MARKED-UP VERSION OF AMENDED CLAIM

<u>REMARKS</u>

This case has been carefully reviewed and analyzed in view of the Official Action dated 13 May 2002. Responsive to the rejections made in the Official Action, Claim 1 has been amended to clarify the combination of elements which form the invention of the subject Patent Application.

FIG.6

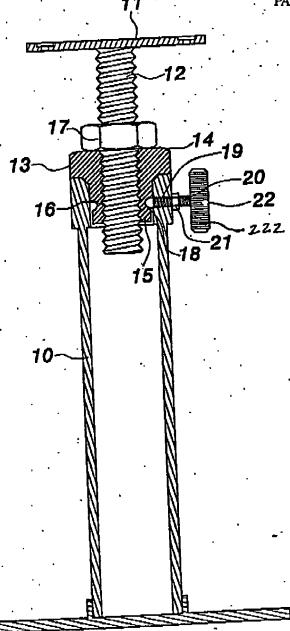
In the Official Action, the Examiner objected to the drawings for failing to comply with 37 C.F.R. § 1.84(p)(5), because they did not include a reference sign mentioned in the Specification. The Examiner stated that the reference numeral 22, shown in FIG. 6, was not mentioned in the Description.

The Specification has been amended to add the reference numeral 22 therein. Further, the knurling shown in FIG. 6 is being added to the Specification and a reference numeral is being added to FIG. 6 to identify the knurling on the perimeter of the circular turn knob 22. As the knurling is clearly shown in FIG. 6, such provides antecedent basis for the addition to the Specification, and thus no new matter has been added thereto. A marked-up copy of the drawing of FIG. 6 is enclosed for the Examiner's approval. A corrected formal drawing will be submitted subsequent to the Examiner's approval of the marked-up drawing and allowable subject matter being found.

As shown in FIG. 6, the invention of the subject Patent Application provides a circular turn button 22 joined to the fixing stud 20, the circular turn button 22 having a knurled perimeter edge 222 so that a user can conveniently tighten or loosen the fixing stud by hand.

Additionally, as shown in Fig. 6, the shape of the retaining groove 18 of the a circular turn button 22 can be formed to present invention can vary. Moreover, the fixing stud can join a larger turn

button so that a user can directly turn it with hands conveniently

button 22 by hand.
